| APPLICATION NO. | FILING DATE | FIRST NAMED INVENTOR | ATTORNEY DOCKET NO. | CONFIRMATION NO. |
|---|-------------|----------------------|---------------------|------------------|
| 10/576,880 | 04/21/2006 | Yoon-Seob Eom | P-0773 | 5874 |

Office Action Summary

DETAILED ACTION

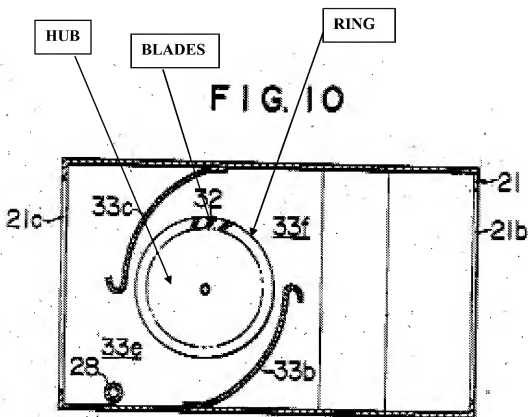
Regarding claim 1, Hosoda et al. teach an air conditioner (figs. 8-10) comprising: a case (21) of which one side is positioned at an indoor side (side adjacent to evaporator 31) and another side is positioned at an outdoor side (side adjacent to condenser 34); an indoor heat exchanger (evaporator 31) mounted inside the case (illustrated in figure 9) positioned at the indoor side (illustrated in figure 9) thus to be heat-exchanged with the indoor air (see arrow flowing through the evaporator); an indoor centrifugal fan (29) opposite to the indoor heat exchanger (illustrated in figure 9) for generating a blowing force so that the indoor air can pass through the indoor heat exchanger (the indoor heat exchanger is capable of performing this

intended use function); an outdoor heat exchanger (34) mounted inside the case (illustrated in figure 9) positioned at the outdoor side (illustrated in figure 9) thus to be heat-exchanged with the outdoor air (see arrow flowing through the condenser); and an outdoor centrifugal fan (32) opposite to the outdoor heat exchanger (illustrated in figure 9) that generates a centrifugal force to blow the outdoor air [this intended use limitation is capable of being performed by the outdoor centrifugal fan], wherein the outdoor centrifugal fan comprises: a hub (annotated below) formed in a disc shape (illustrated below) connected to a driving motor (35) by a rotational shaft (shaft extending between the motor and both blowers 29 and 32); a plurality of blades (annotated below) each having one end protruding from a surface of the hub (illustrated below) and disposed at the outer side of the hub in a circumferential direction (illustrated below) with the same interval therebetween (illustrated below); and a supporting ring (the ring as annotated below) coupled to another end of each of the plurality of blades to support the blades [as illustrated below, portions of the ring are disposed in a vicinity between the blades]. It is noted that the Applicant has not specified the boundaries of the indoor side and the outdoor side.

Regarding claim 2, Hosoda et al. teach the limitation of an outdoor air suction port (21a) being respectively formed at both lateral surfaces of the case (as illustrated in figure 8, since the outdoor suction port has a surface area, it is disposed at "lateral sides" of the case) positioned at the outdoor side (illustrated in figure 8), and an outdoor air discharge port (34) is formed at the rear surface of the case (illustrated in figure 8).

BLOWN UP VERSION OF FIGURE 9

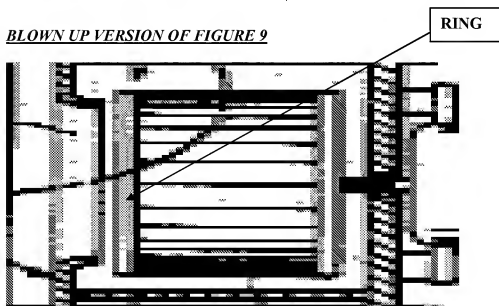
Regarding claim 3, Hosoda et al. teach the limitation of the outdoor fan being installed in a shroud (the combination of 24 and 25) mounted inside the case positioned at the indoor side (illustrated in figure 9), and the shroud is provided with an air guide (25) that guides air blown from the outdoor centrifugal fan to the outdoor heat exchanger [illustrated in figure 9].

Regarding claims 5 and 6, Hosoda et al. teach a condensing water dispersing ring (39) mounted at the outdoor centrifugal fan (illustrated in figure 9) for dispersing condensing water collected at the lower surface of the case to the outdoor heat exchanger (the dispersion unit is positioned to perform this intended use function), the condensing water dispersing ring being connected to the outdoor fan thus to be rotated together for dispersing the condensing water (see column 7, lines 7-10).
